**PROCUREMENT SERVICES
ADDENDUM**

Date of Notice:	1/22/2025
Solicitation No.:	IB-010-25
Title:	HSC Restroom Renovations
Addendum No.:	1

IB-010-25

Addendum 1

PLAN LEGEND

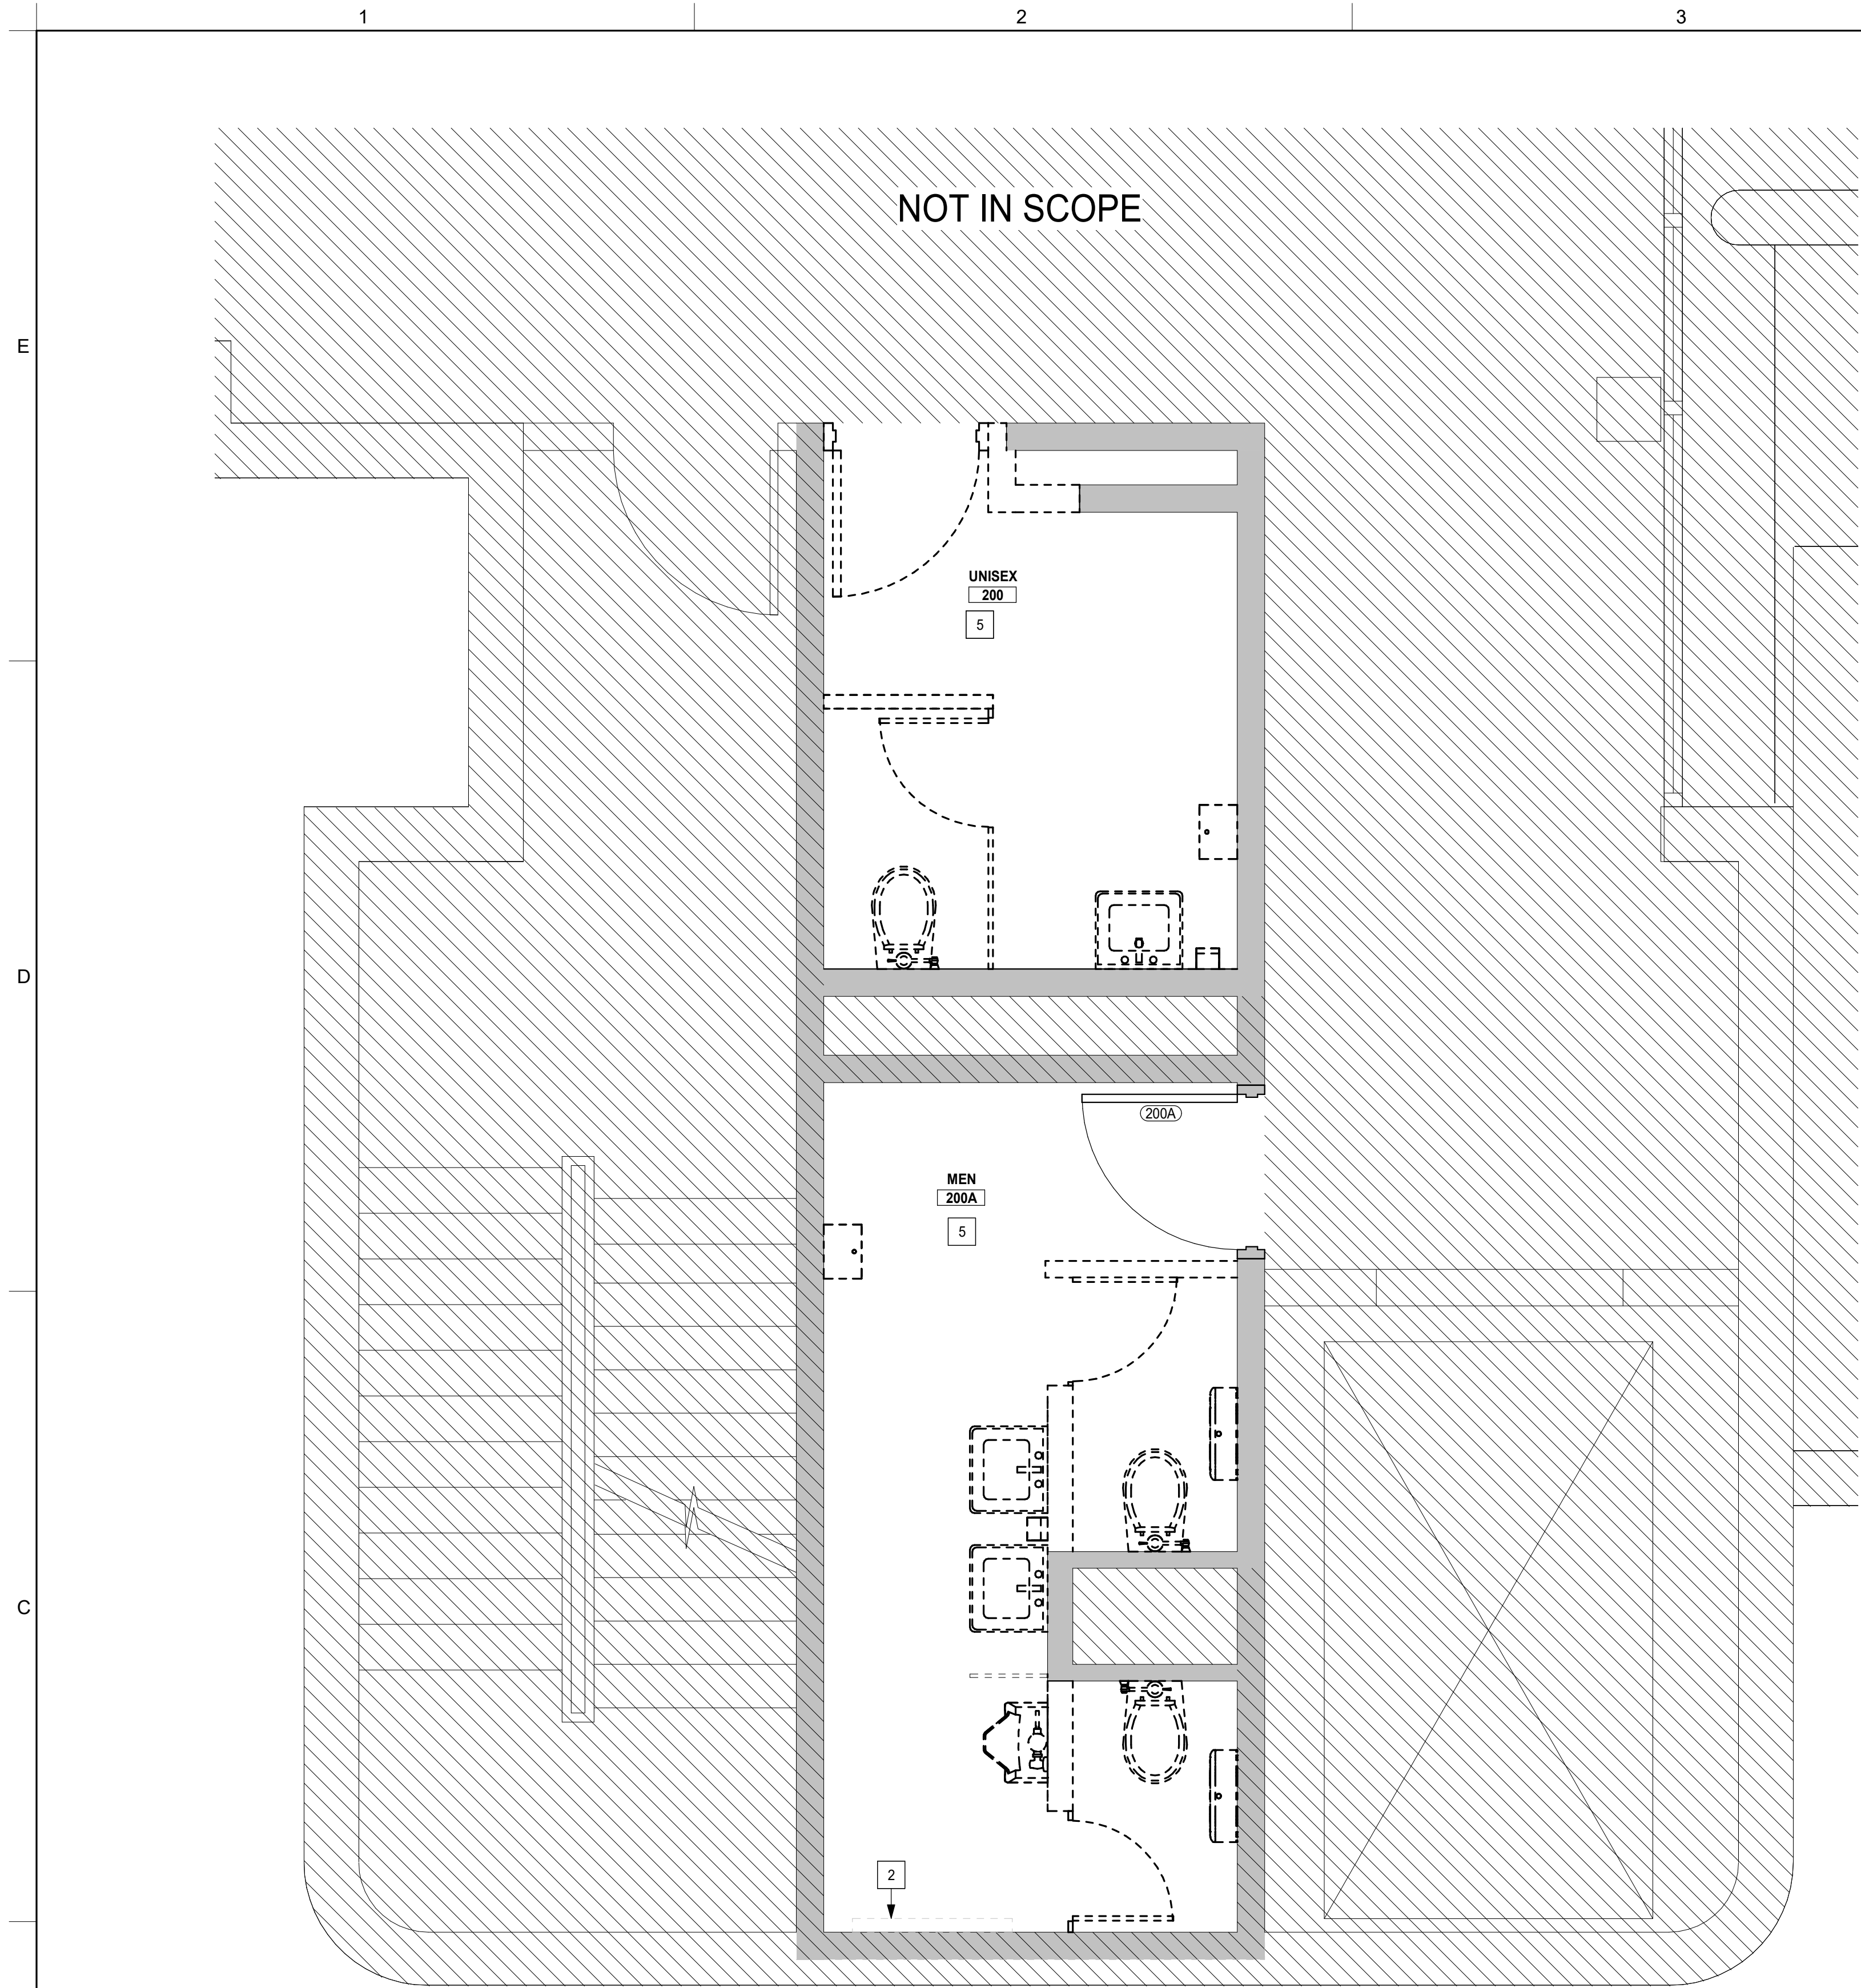
8. **Clarification Item 1:** Within the 55B 1st Floor scope, ceiling material has been updated. See **revised 55B-202** attached for clarification.
9. **Clarification Item 2:** Within the 55B 2nd Floor scope, flooring material is shown for scope clarity. Additionally, the door and mop sink location within Janitor Closet 299D have been updated. See **revised sheet 55B-103** attached for clarification.
10. **Clarification Item 3:** Within the 55B scope, Sheet Note 17 has been updated, see **revised sheets 55B-102 and 55B-103**.
11. **Clarification Item 4:** Within the 55A scope, Sheet Note 7 has been added, see **revised sheets 55A-101, 55A-102, and 55A-103**.
